DENDROBIUM AREA 3C LONGWALL 20-21 SUBSIDENCE MANAGEMENT PLAN Reasons for Approval

Fig 2: Location of Longwalls 21 and 20.

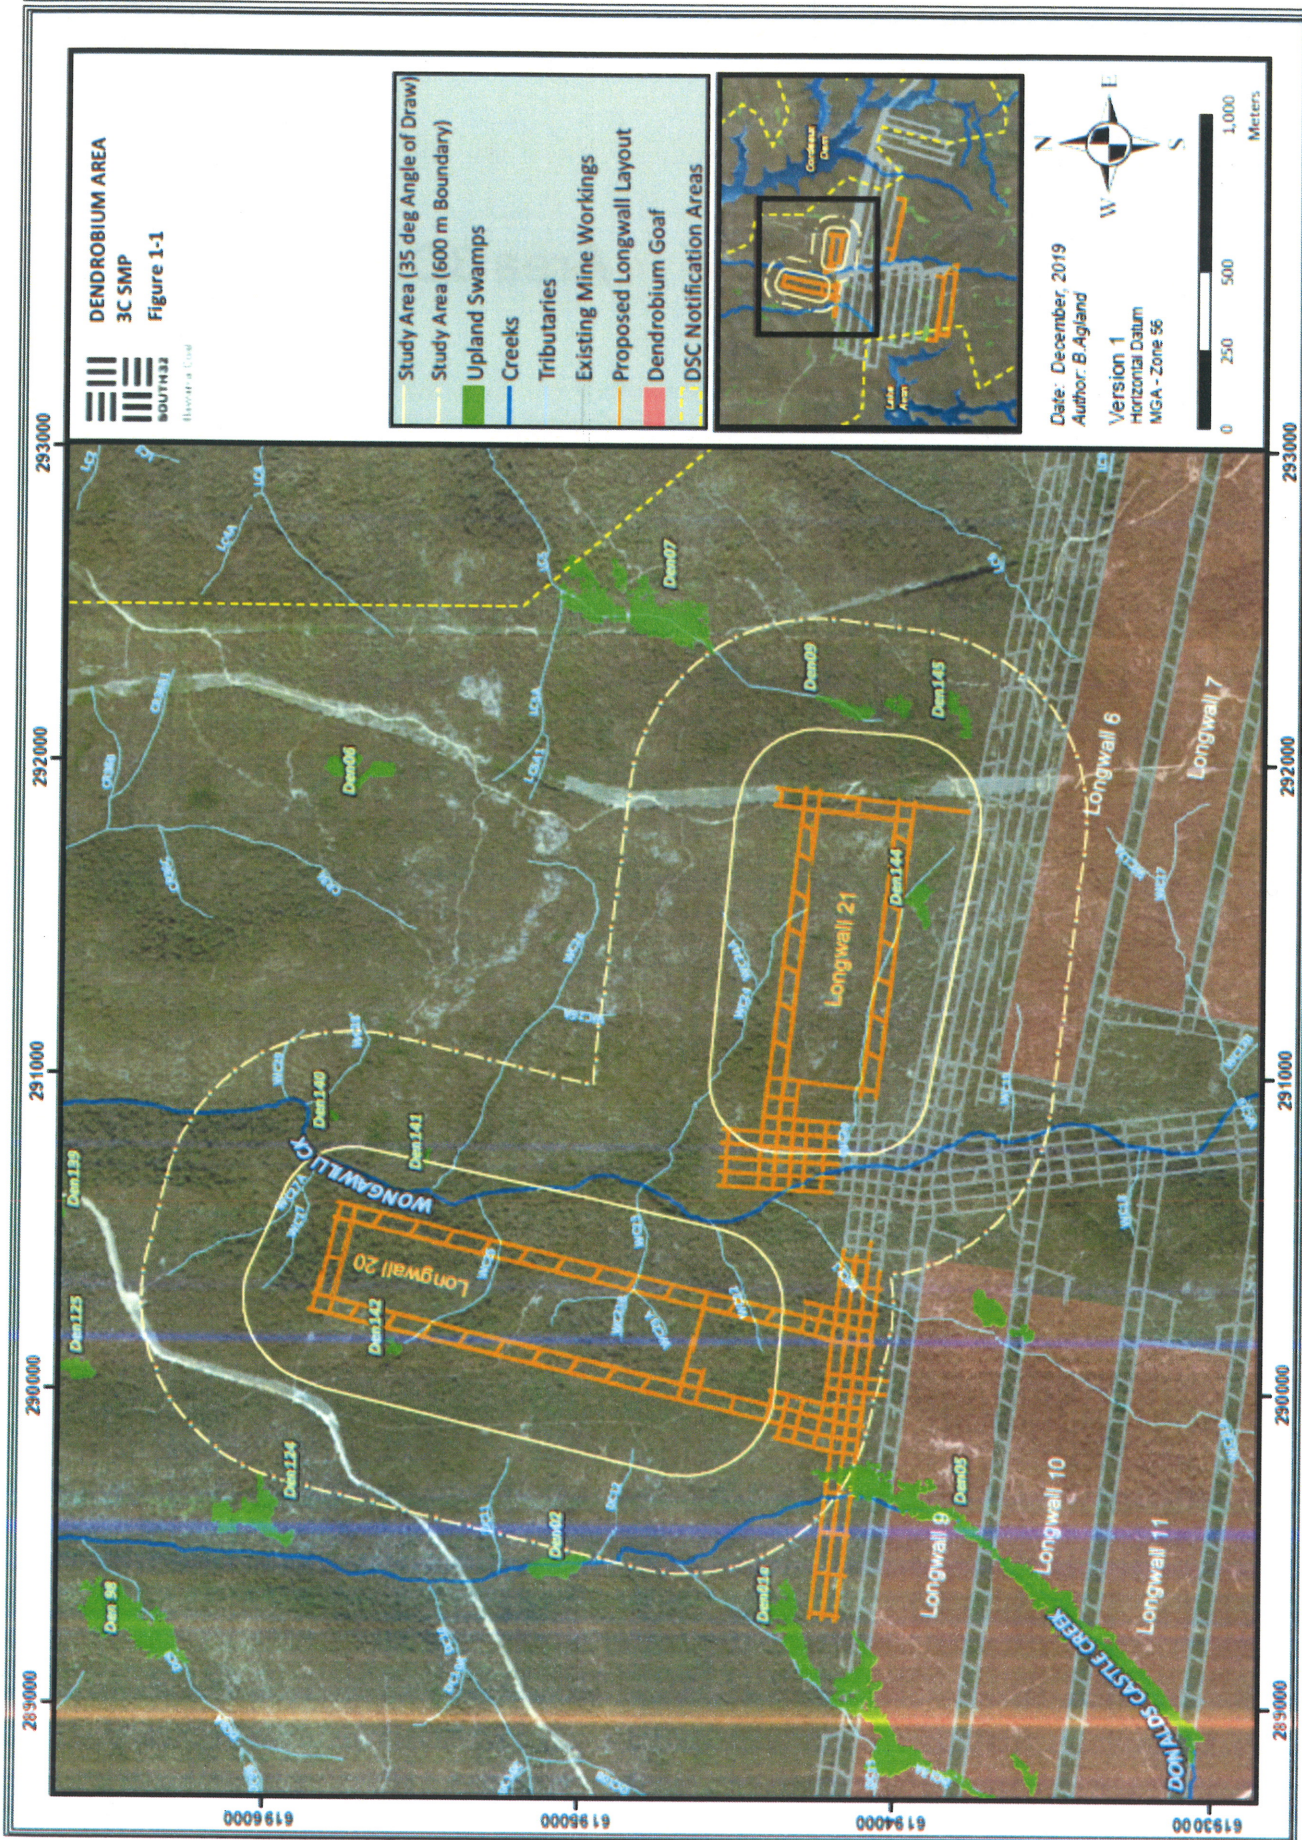
- The key differences between the two longwalls include the:
 - proposed orientation of Longwall 20 is roughly parallel to Wongawilli Creek, which substantially increases the length of the creek which may be subject to valley closure, surface cracking and the area of its catchment that may be subject to groundwater depressurisation (and therefore baseflow reduction) and at the same time reduces adaptive management options;

- centreline of Wongawilli Creek is just 125 m east of the tailgate of Longwall 20 but 240 m west of the finishing end of Longwall 21, at the closest points to the proposed total longwall voids. The closer proximity increases the predicted valley closure; and

- proposed extraction of Longwall 21 is from east to west, which allows for adaptive management through shortening the longwall ("pulling up short") should subsidence effects in Wongawilli Creek exceed permitted levels.

- For these reasons, advice received from WaterNSW focussed on issues relating to Longwall 20. PAG agrees with this position and considers that Longwall 21 has substantially fewer associated risks.

“It is possible that LW 21 will result in seam-to-surface connective fracturing over some areas, albeit less extensive than over previous 305 m wide longwalls. In the given site-specific conditions, panel width may need to be reduced to the order of 200 m if seam-to-surface connective fracturing is to be totally avoided.

- At the present time, some doubt exists as to whether both of these performance measures can be met if Longwall 20 is extracted as proposed and PAG has therefore sought further information from South32. However, PAG is satisfied that Longwall 21 can be extracted, as proposed under the SMP, with a low risk of exceedance of either of these two performance measures, particularly if the Panel's advice is applied.
